APPLICATION NO.	FILING DATE	FIRST NAMED INVENTOR	ATTORNEY DOCKET NO.	CONFIRMATION NO.
09/588,924	06/06/2000	Roger P. Jackson	00,063	9408

<b>Advisory Action</b>	Application No.	Applicant(s)
	09/588,924	JACKSON, ROGER P.
	Examiner D Jacob Davis	Art Unit 3731

10.  Other: Response to arguments

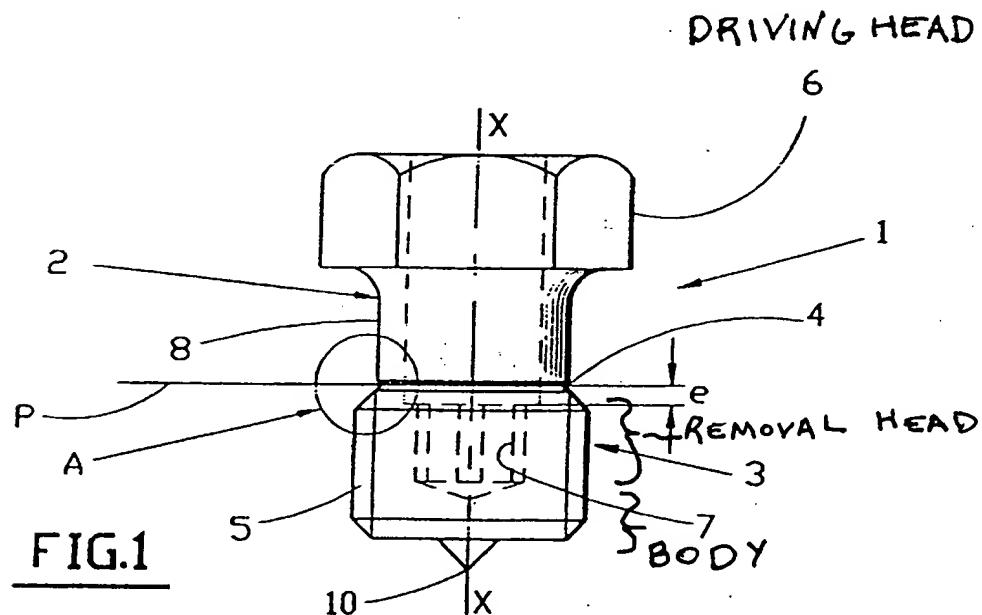
Applicant stated that Gournay et al. (US 6,193,719) did not disclose a removal head located between the driving head and body. For clarification, Gournay discloses in Figure 1 an implant having a driving head 6, a body, and a removal head as illustrated below. The removal head is located between the body and the driving head 6.
